# PERMIT CHANGE TRACKING FORM

DATE RECEIVED <b>9-5-95</b>	By: <b>SLO</b> <small>(initials)</small>	PERMIT NUMBER	ACT/007/033
Title of Proposal: <b>Stockpile Culvert Installation</b>		PERMIT CHANGE #	<b>95B</b>
Description: <b>Install 12" CMP to carry runoff from the stockpile pad to the drainage ditch below.</b>		PERMITTEE	ANDALEX RESOURCES, INC.
		MINE NAME	WILDCAT LOADOUT

TO: Joe Helfrich, Permit Supervisor  
FROM: Stephen Demczak, Reclamation Specialist III  
RE: Installation of Two 12" Culverts from Pad Area Runoff,  
Wildcat Loadout, Andalex Resources, Inc., ACT/007/033-  
95B, Folder #3, Carbon County, Utah *SD*

Re: *Proposed Pad Culverts  
Wildcat Loadout*

Wildcat Loadout  
Drainage Control  
Proposed Location

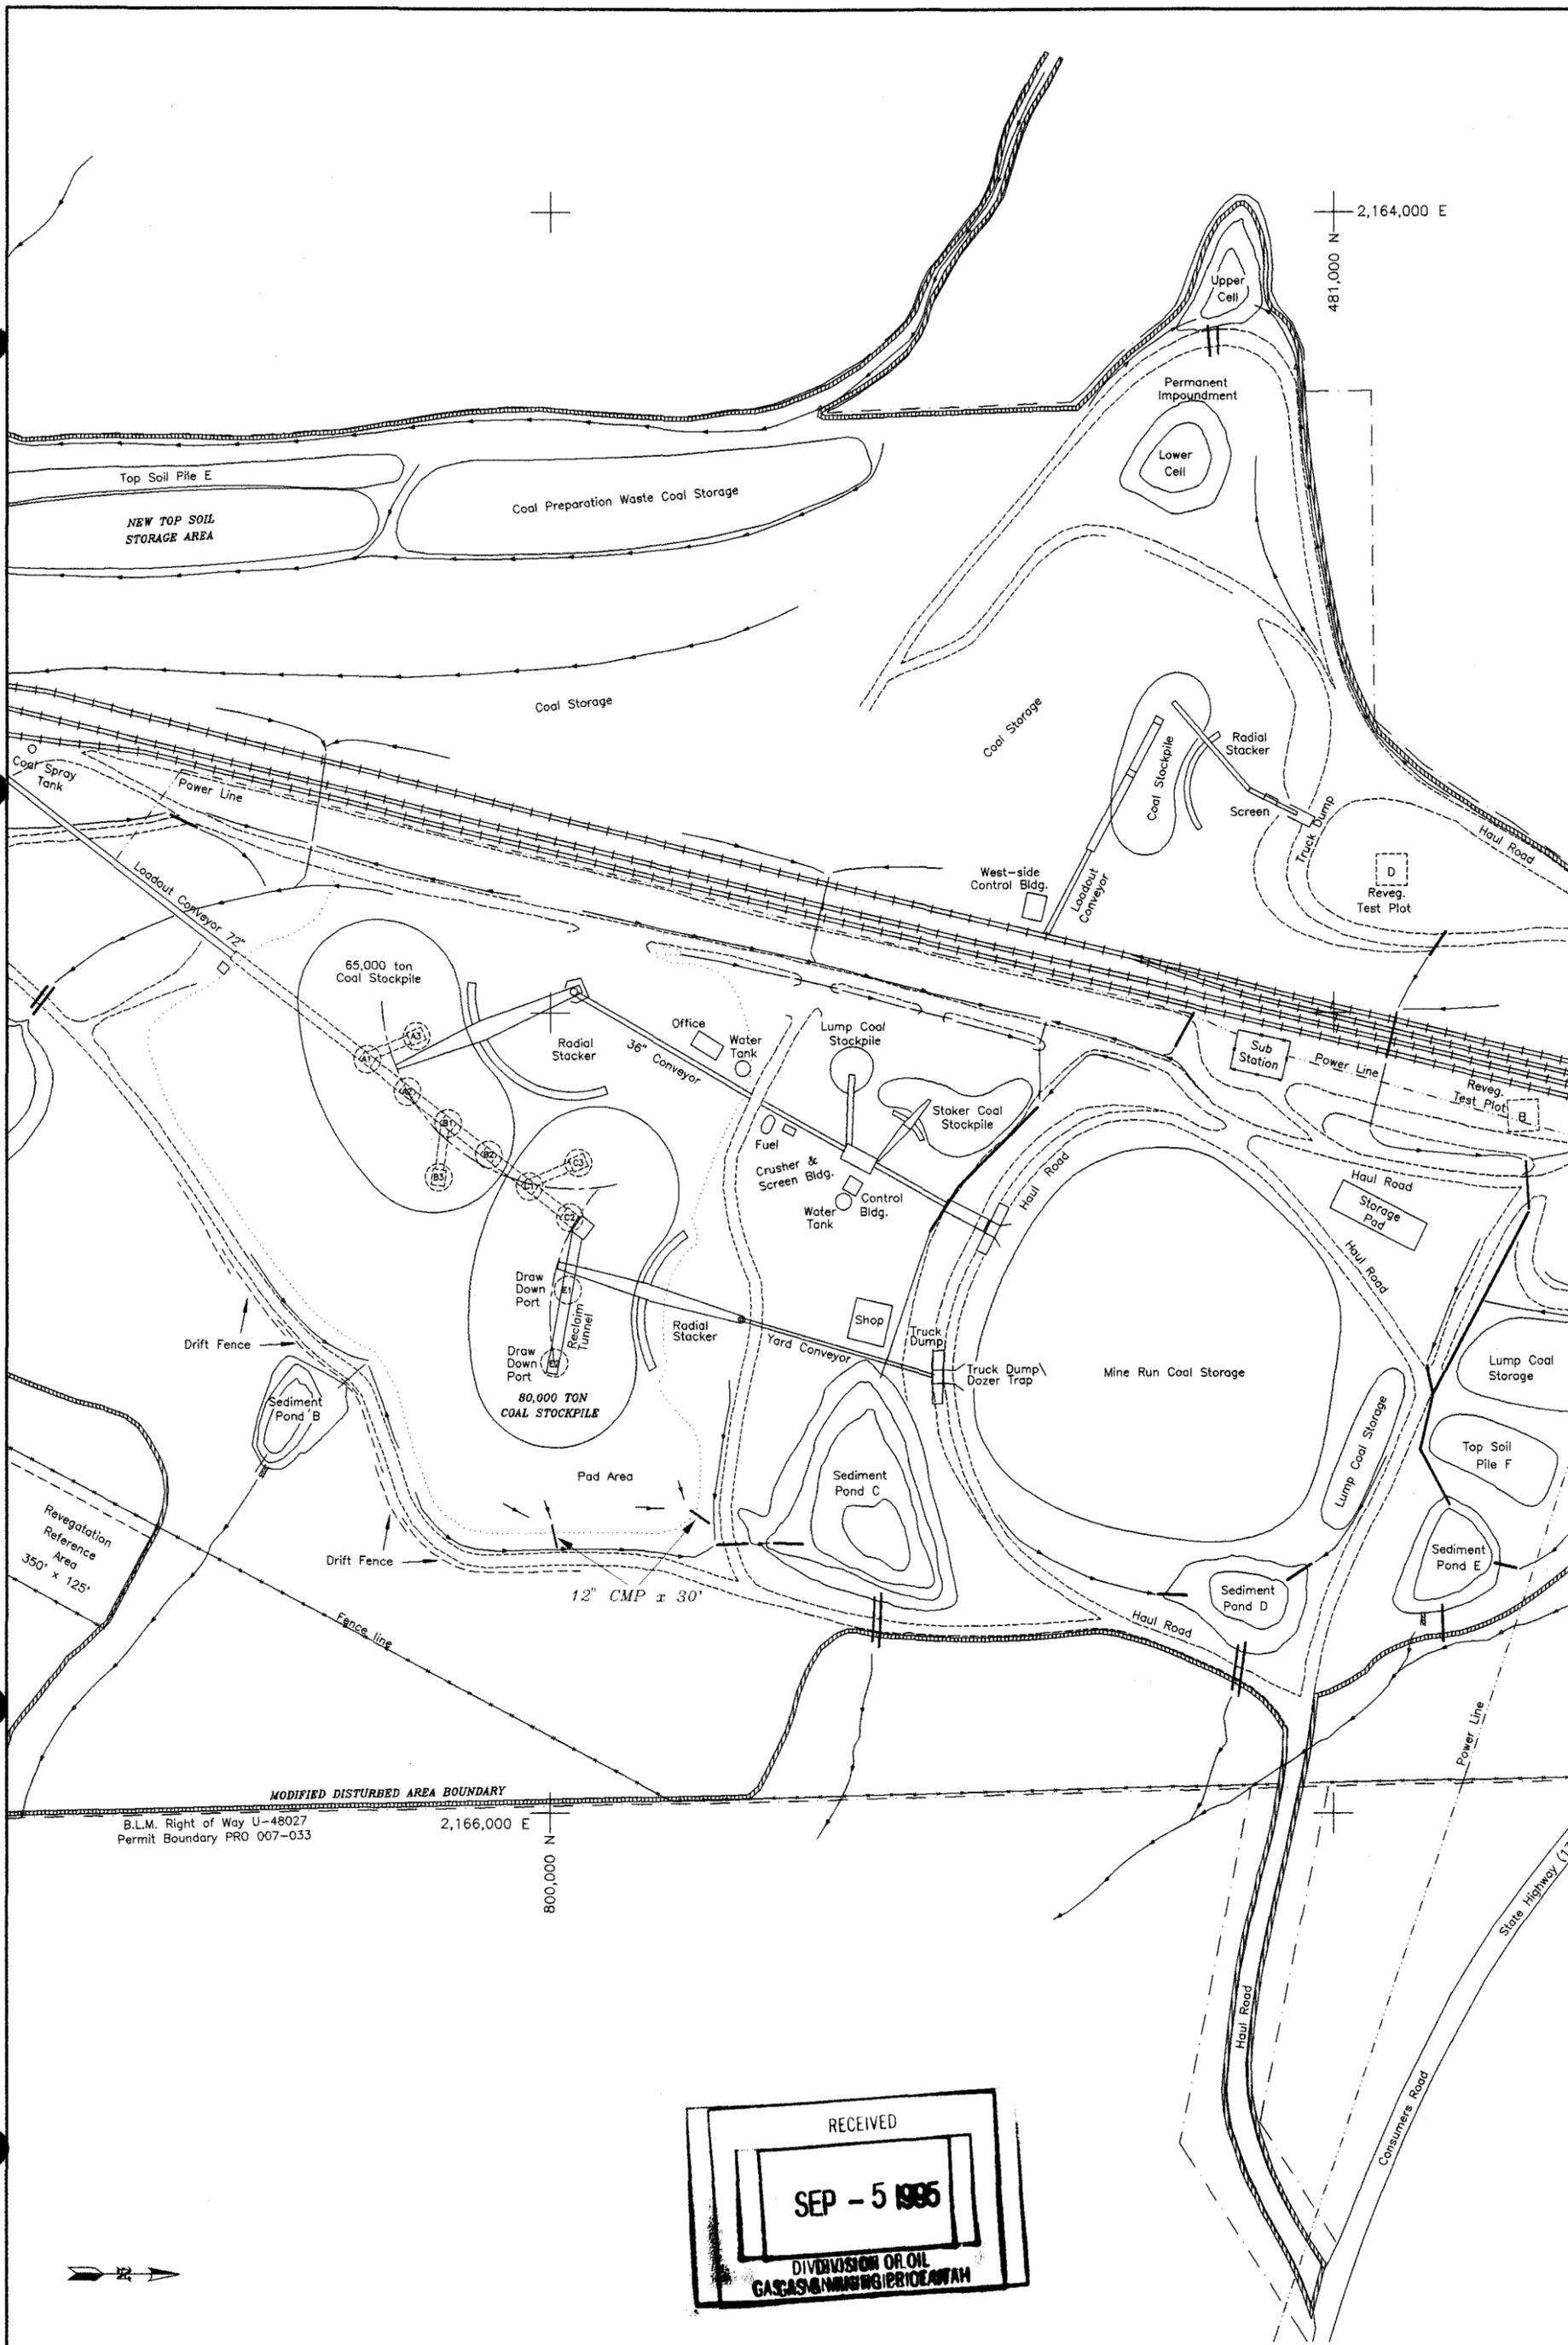
- 1) The permittee has submitted all the necessary designs and calculations for installing two 12" inch culverts from the pad area to the disturb diversion ditch. The drainage ditch which accepts water flow from the pad area has been designed for this drainage area, and therefore does not need to be re-designed. The calculations and maps are P.E. certified as required in the R645 regulations.
- 2) Installing two additional culverts within the disturb area does not need to be reviewed by any other agencies, since it does not change any existing environmental concerns.
- 3) The bonding amount will not need to be changed since there is a contingency to the bond greater than the costs of removing the two culverts.
- 4) This amendment will not have any impact on the hydrologic balance of this area.
- 5) The Technical Analysis document does not need to be updated with this amendment.

Andalex Resources, Inc. has addressed and met the requirements of the R645 regulations and ACT/007/033-95B is therefore approved effective September 11, 1995.
